Lake Forest Park
STRIDE S3 SR522/145 BRT LFP Impacts

Citizens Organized to Rethink Expansion
CORE
522 in LFP

LAKE FOREST PARK 60% ALIGNMENT OVERLAY

This alignment overlays the 60% landscape plans on SR522/145 BRT LFP

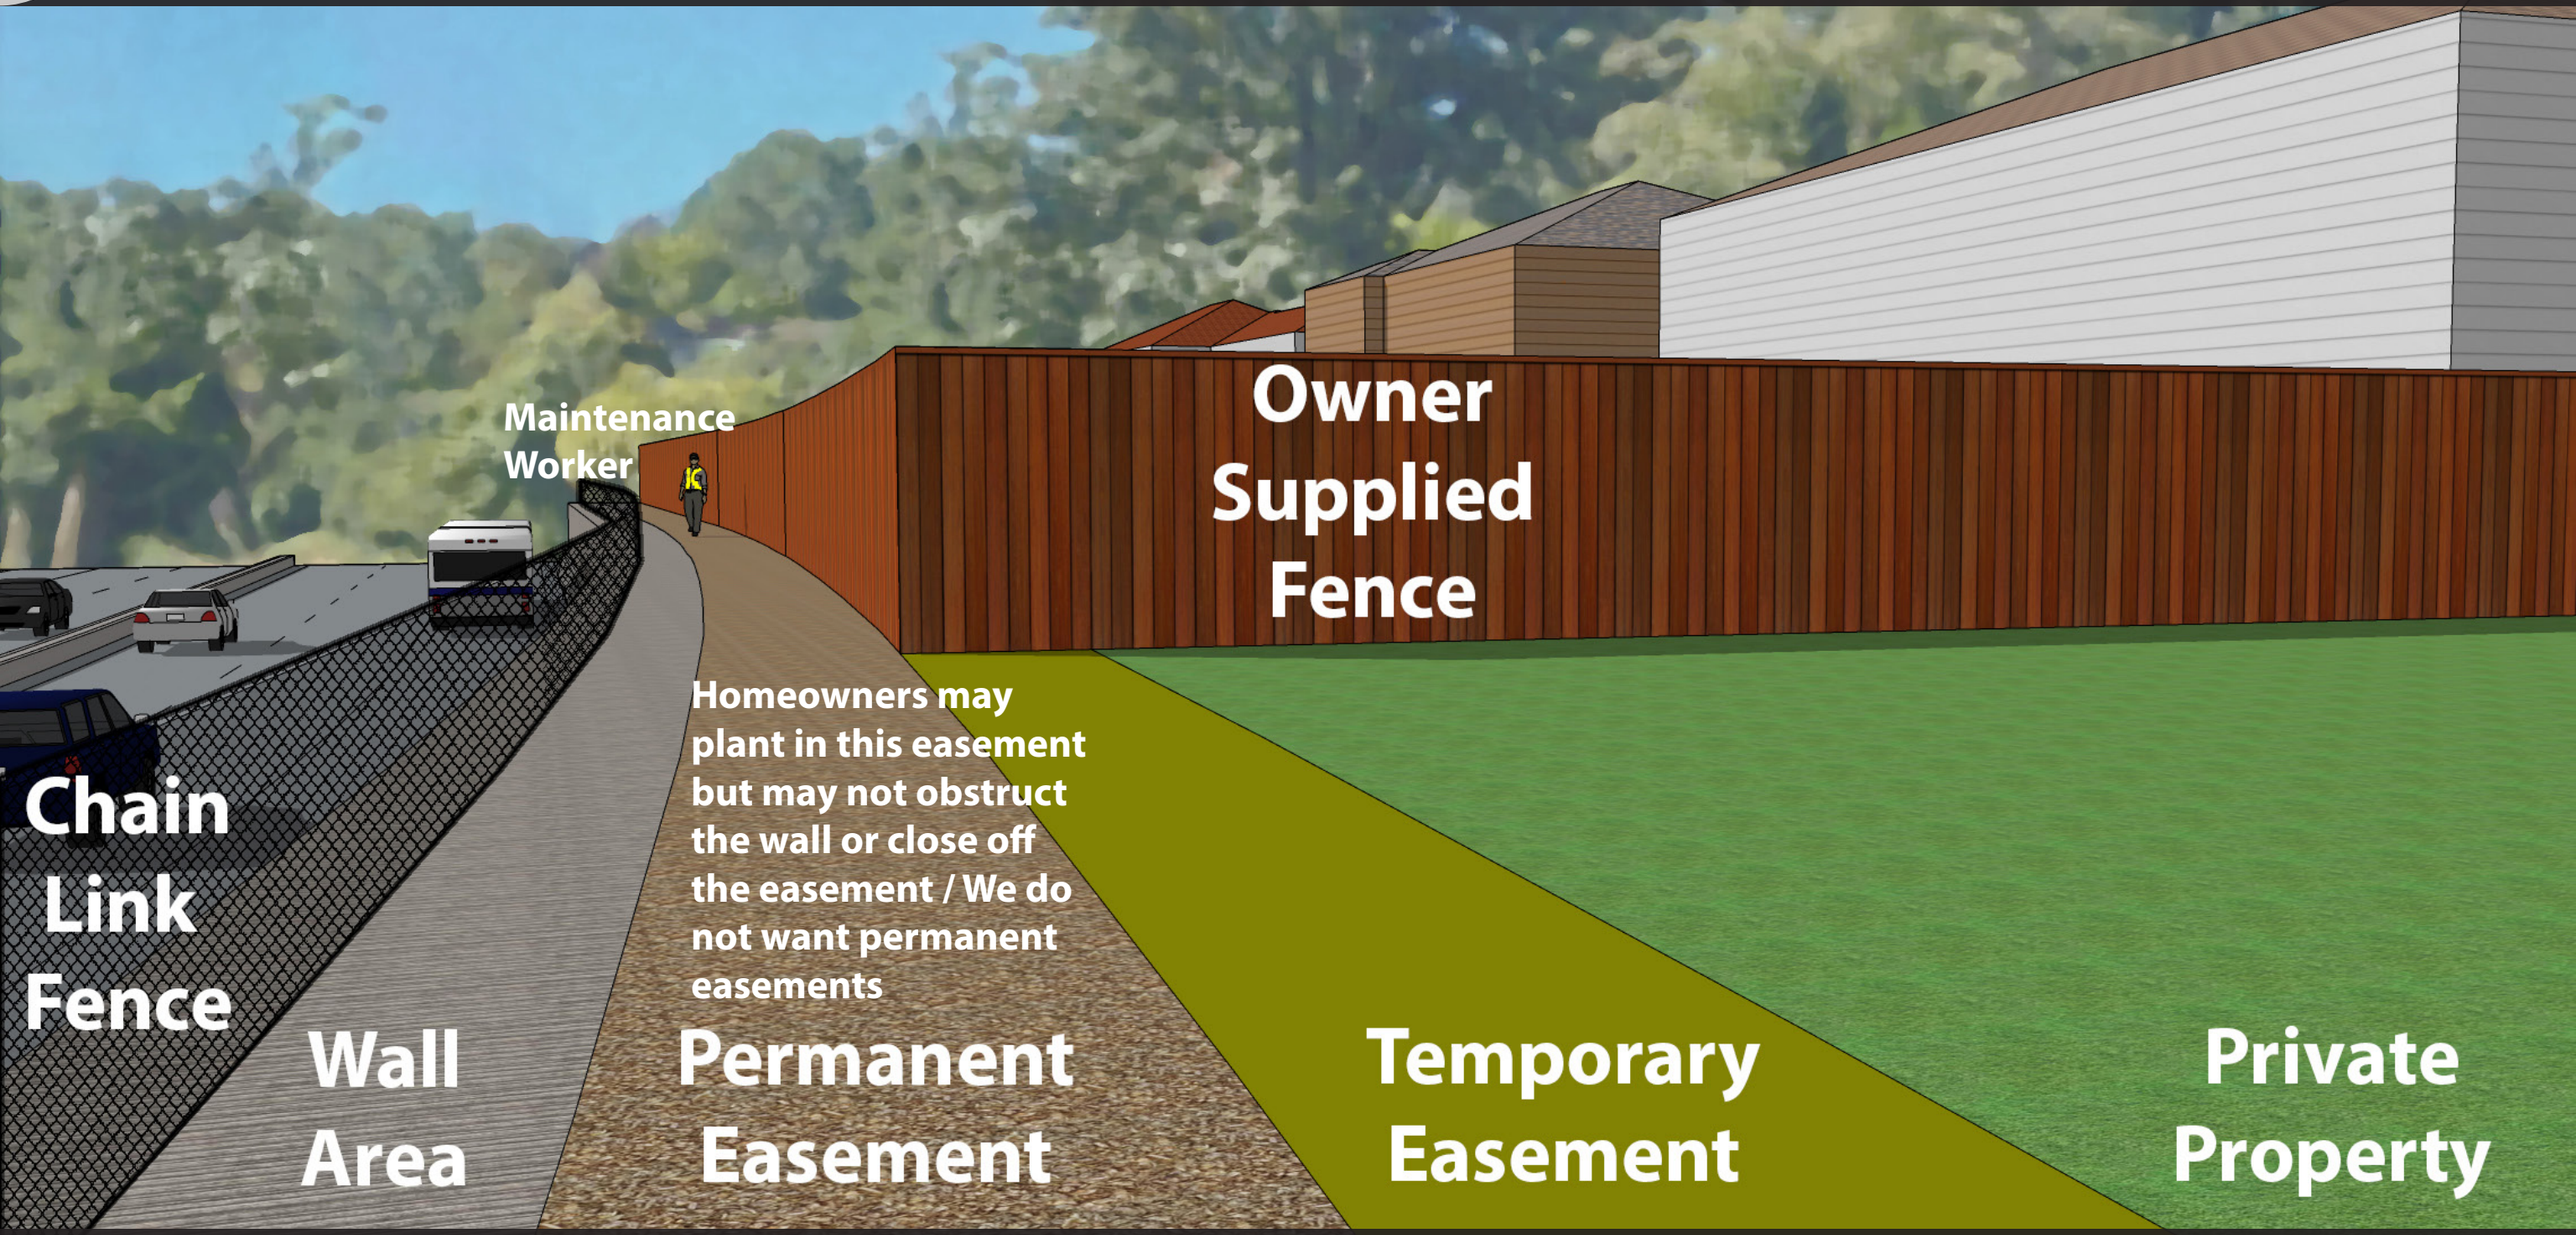
SR 522 NE 145 BRT LFP Locates a Variable Height Concrete Wall Along 1.2 Miles of Bothell Way

Expansion Impacts 16' Inside Property Lines of 38 Homes on the West Side of Bothell Way

SR 522 NE 145 BRT LFP Wall and Black Chain Link Fence Do Not Provide Noise Mitigation

The Permanent Easement Impacts Homeowner Privacy, Security & Property Values

Add: Planted Retaining Walls and Sound Walls with Vines Growing from Top and Bottom

Figure 6-2 Noise monitoring locations: Segments 2/3 - Lake Forest Park/Kenmore

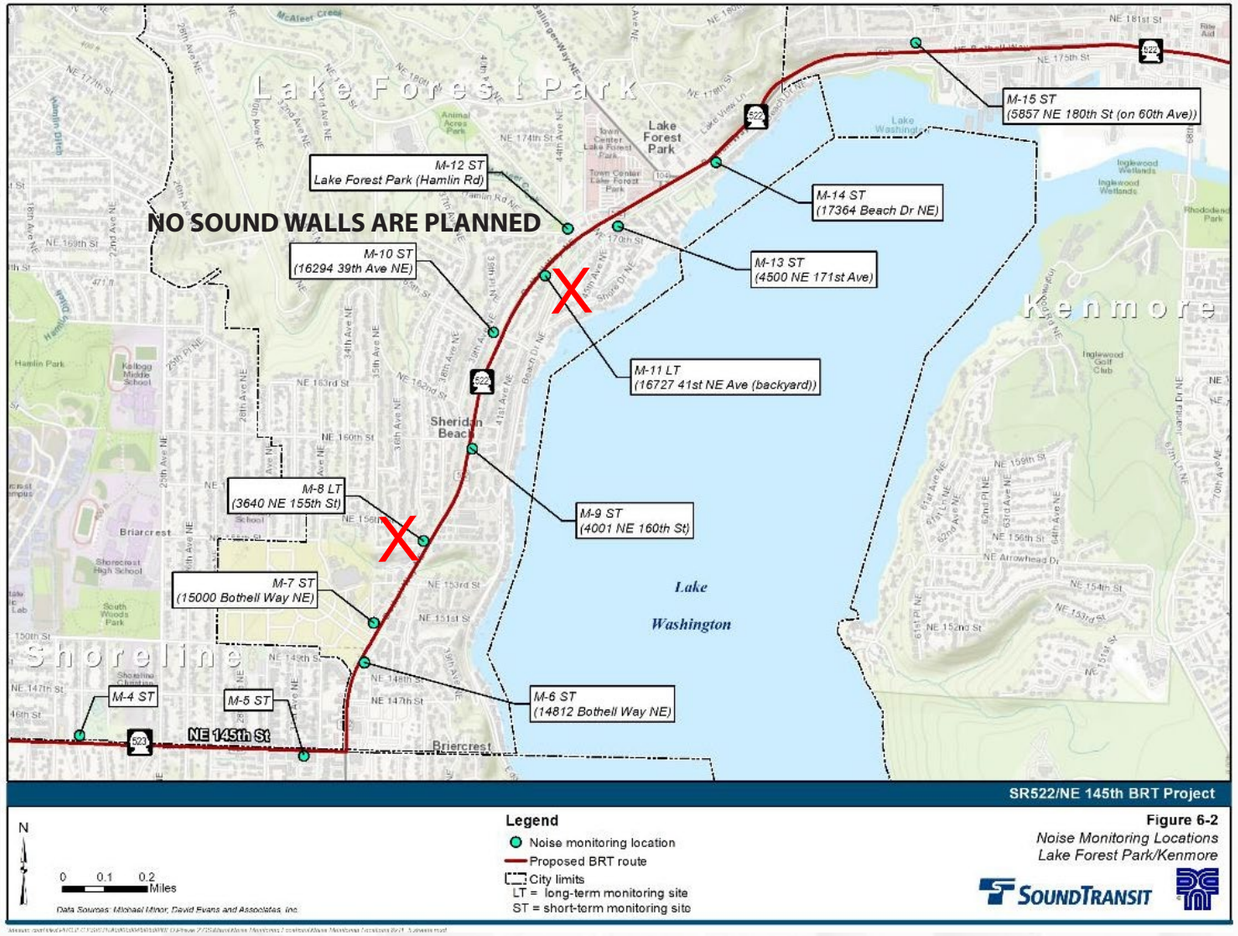
Only Two Locations, M-8 and M-11 were studied for 24 hours: See 6.3. Project Area Noise Level
The residential neighborhoods along 39th Ave NE (abutting Bothell Way) and residences along Bothell Way are not adequately considered in this study. This is a gross omission, as noise impacts most affect the residential neighborhoods along both sides of Bothell Way.

Note: There are no noise samples taken along Bothell Way where the highway expansion creates the most noise impacts for residents of Lake Forest Park.

Also, the 24 hour noise sampling is shown at areas designated by the red X's, far away from the most impacted segments of the road. It seems this Noise Report was done before the highway expansion to the west side of Bothell Way. Sound Transit's conclusion that there are no noise impacts along this corridor is flawed. Their sampling reflects a bias to produce a favorable outcome for Sound Transit, not for Lake Forest Park residents.

TREE REMOVAL: 28 TOTAL
EAST: 28
WEST: 0

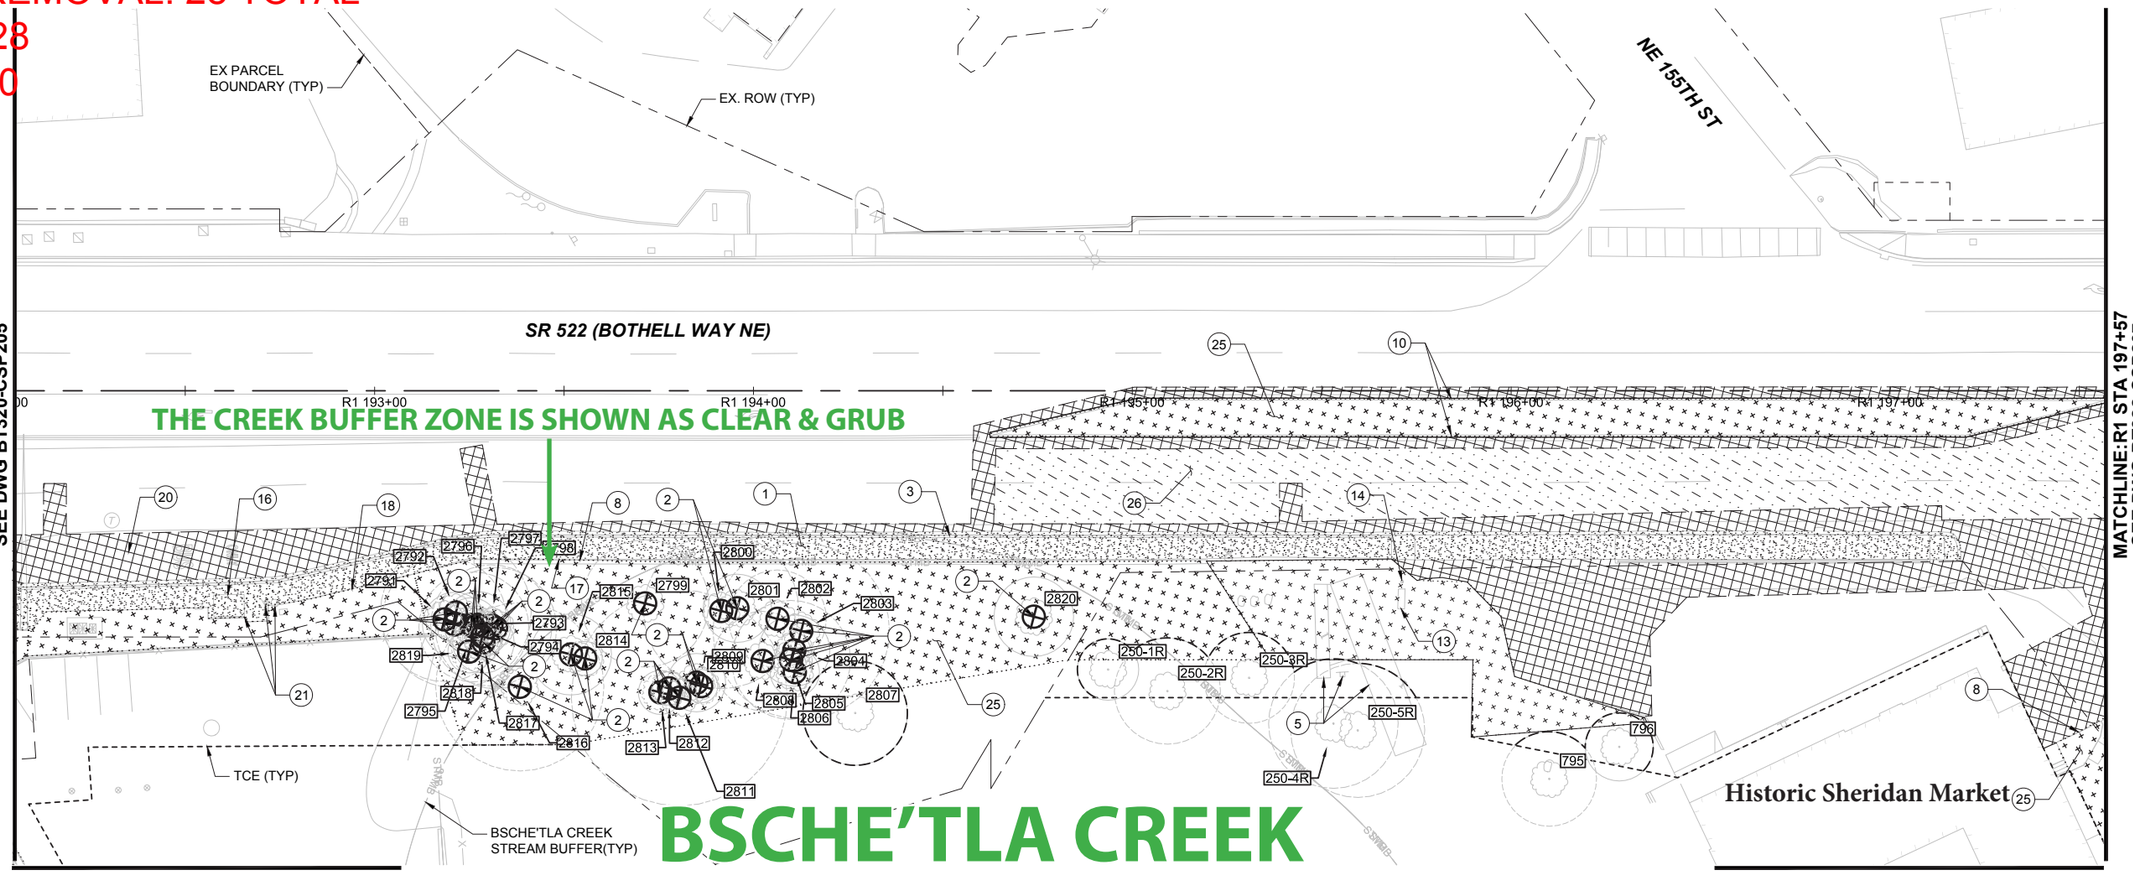
THIS SWATH ON THE WEST SIDE OF BOTHELL WAY IS TYPICALLY 16' WIDE STARTING AT 38TH AVENUE NE CONTINUING TO ACROSS FROM 41ST STREET NE: 60,000 SQ FEET IS CLEARED AND GRUBBED; ABOUT HALF OF THAT IS ACQUIRED ALONG JUST THIS STRETCH

NEIGHBORHOOD ENTRY AT 165TH STREET NE

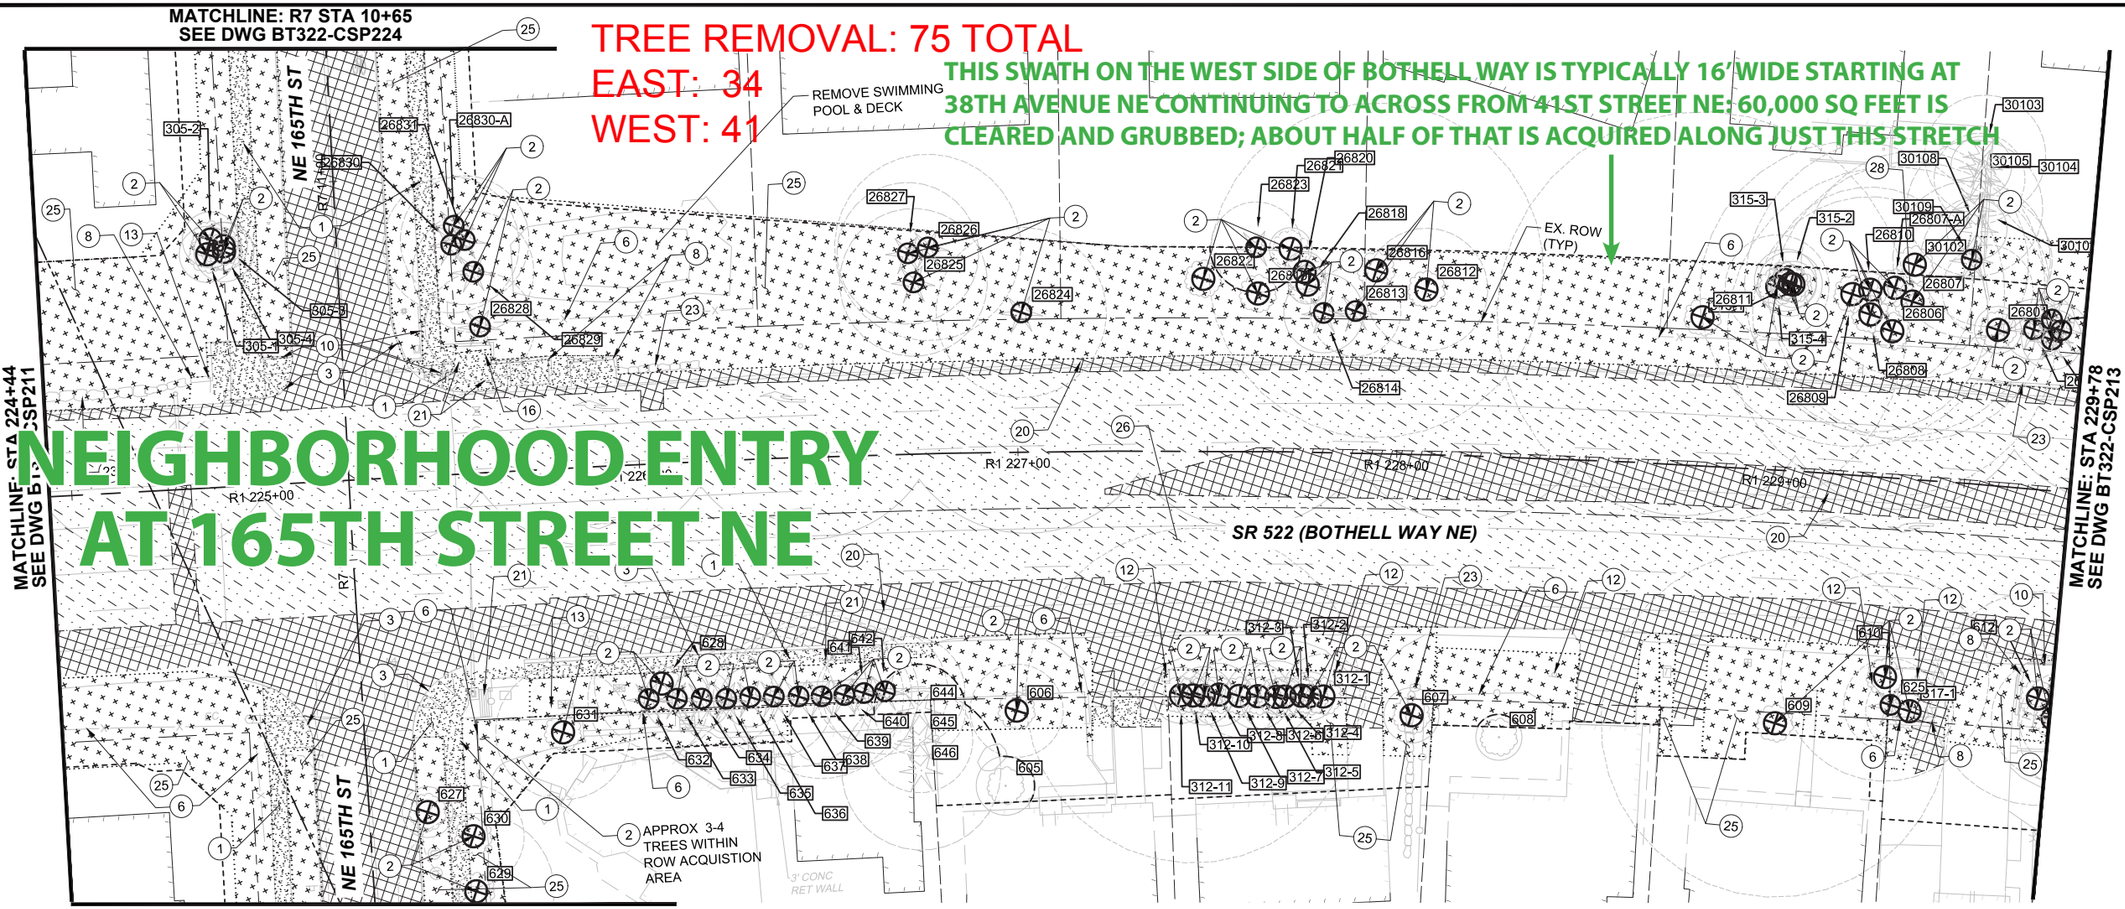
NOTE: THE TURNAROUND DRIVEWAYS ON THE EAST SIDE OF BOTHELL WAY ARE FORCING TREE REMOVALS ON BOTH SIDES OF BOTHELL WAY
